**FINAL EXPRESS TERMS
FOR
PROPOSED BUILDING STANDARDS
OF THE
DIVISION OF THE STATE ARCHITECT (DSA-AC)

REGARDING THE CALIFORNIA BUILDING CODE
CALIFORNIA CODE OF REGULATIONS, TITLE 24, PART 2

2013 CALIFORNIA BUILDING CODE
INTERVENING CODE CYCLE**

Figure 11B-307.4.1
Guy Braces (end underline)

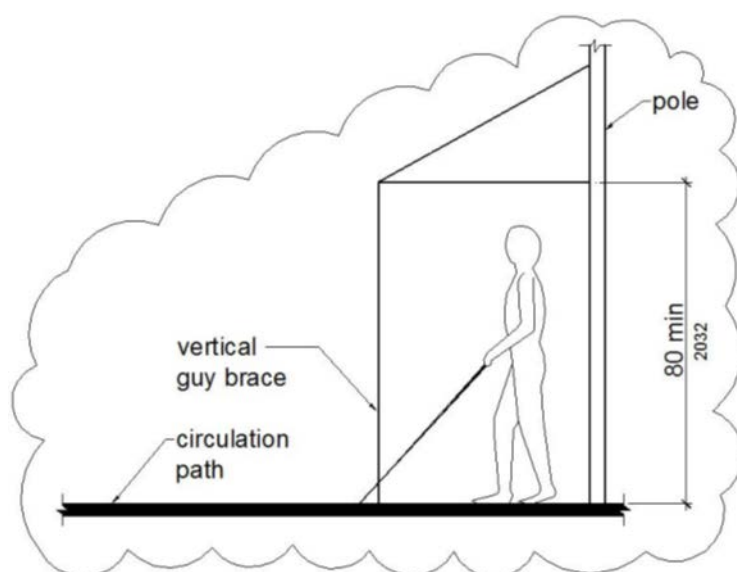
(begin underline) **11B-307.4.1 Guy braces.** *Where a guy support is used within either the width of a circulation path or 24 inches (610 mm) maximum outside of a circulation path, a vertical guy brace, sidewalk guy or similar device shall be used to prevent a hazard or an overhead obstruction.*

Figure 11B-406.3.2
Parallel Curb Ramps

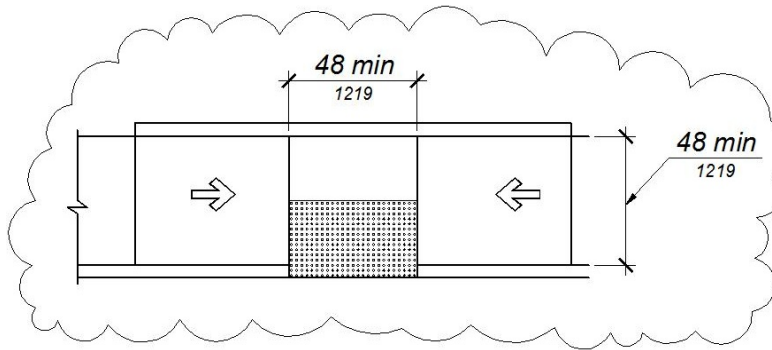
Revised Figure 11B-406.3.2 showing a parallel curb ramp without a grooved border.

Figure 11B-411.2.1.2.3
Destination-Oriented Elevator Accessibility Function Button Indication

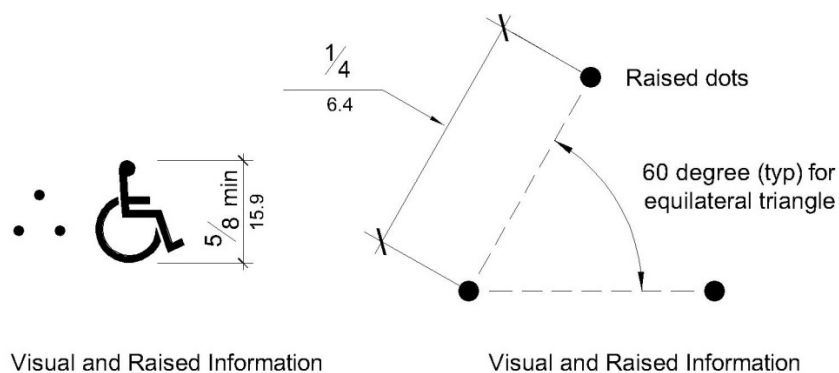
11B-411.2.1.2.3 Accessibility function button. The accessibility function button shall be identified by the International Symbol of Accessibility and a raised indication. The International Symbol of Accessibility shall comply with Section 11B-703.7.2.1, and shall be 5/8 inch (15.9 mm) minimum in height. The indication shall be three raised dots. Each dot shall have a base diameter of 0.059 inch (1.5 mm) minimum and 0.063 inch (1.6 mm) maximum and a height of 0.025 inch (0.6 mm) minimum and 0.037 inch (0.9 mm) maximum. The dots shall be spaced 1/4 inch (6.4 mm), measured center to center, in the form of an equilateral triangle with a vertex pointing up. The accessibility function button shall not be provided with a key repeat function.

Figure 11B-411.2.3
Floor Designation and Car Designation Signs on Jambs
of Destination-Oriented Elevator Hoistway Signs

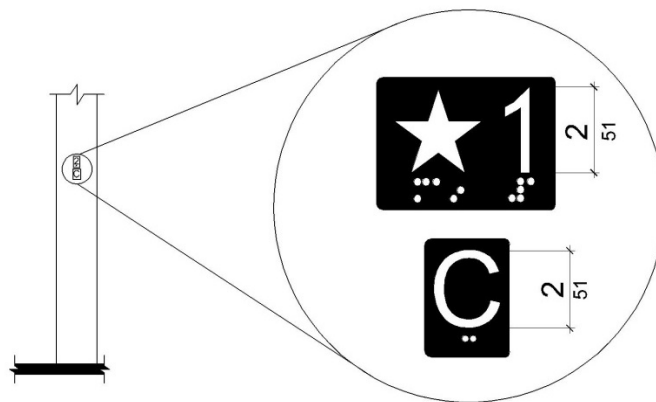
11B-411.2.3.1 Floor designation signs. *Floor designation signs complying with Sections 11B-703.2 and 11B-703.4.1 shall be provided on both jambs of elevator hoistway entrances. Signs shall be provided in both raised characters and Braille. Raised characters shall be 2 inches (51 mm) high. A raised star placed to the left of the floor designation, shall be provided on both jambs at the main entry level. The outside diameter of the star shall be 2 inches (51 mm) and all points shall be of equal length. Raised characters, including the star, shall be white on a black background. Braille complying with Section 11B-703.3 shall be placed below the corresponding raised characters and the star. The Braille translation for the star shall be "MAIN". Applied plates are acceptable if they are permanently fixed to the jamb.*

11B-411.2.3.2 Car designation signs. *Car designation signs complying with Sections 11B-703.2 and 11B-703.4.1 shall be provided on both jambs of the hoistway immediately below the floor designation. Signs shall be provided in both raised characters and Braille. Raised characters shall be 2 inches (51 mm) high. Raised characters shall be white on a black background. Braille complying with Section 11B-703.3 shall be placed below the corresponding raised characters. Applied plates are acceptable if they are permanently fixed to the jamb.*

Figure 11B-407.2.3.2
Car Designations on Jambs of Destination-Oriented Elevator Hoistway Entrances
(end strikeout)

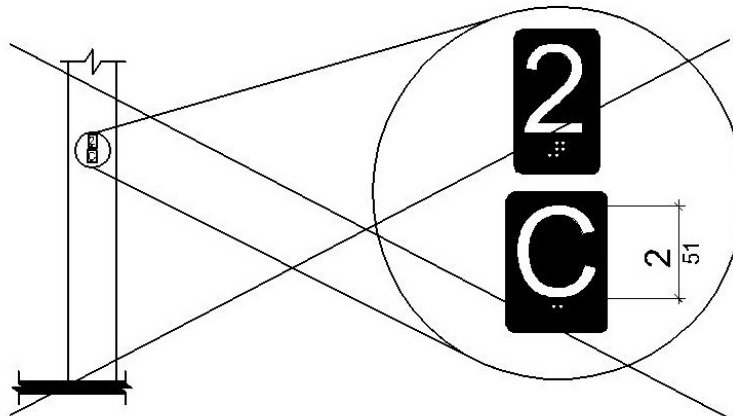
11B-407.2.3.2 (begin underline) **Reserved.** (end underline) (begin strikeout) **Car designations.** Destination-oriented elevators shall provide tactile car identification complying with Sections 11B-703.2 and 11B-703.4.1 on both jambs of the hoistway immediately below the floor designation. Car designations shall be provided in both raised characters and Braille. Raised characters shall be 2 inches (51 mm) high. Raised characters shall be white on a black background. Braille complying with Section 11B-703.3 shall be placed below the corresponding raised characters. Applied plates are acceptable if they are permanently fixed to the jamb.

Figure 11B-703.8.5
Low Resolution VMS Signage Characters

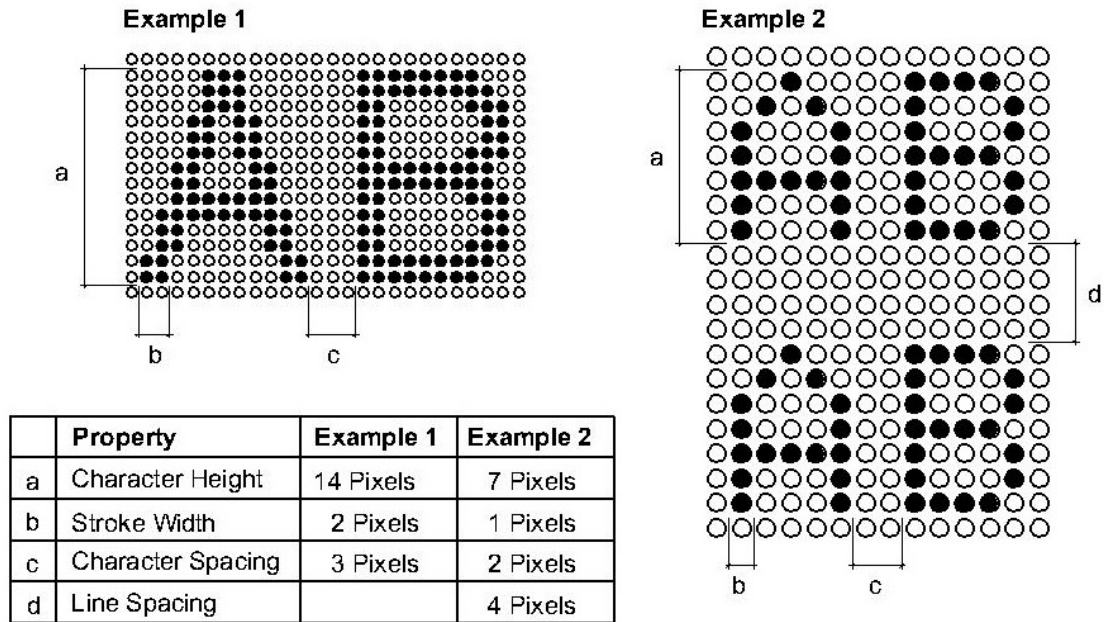
11B-703.8.6 Stroke width. *The uppercase letter “I” shall be used to determine the allowable stroke width of all low resolution VMS characters of a font. Low resolution VMS characters shall comply with the pixel count for stroke width in Table 11B-703.8.5.*
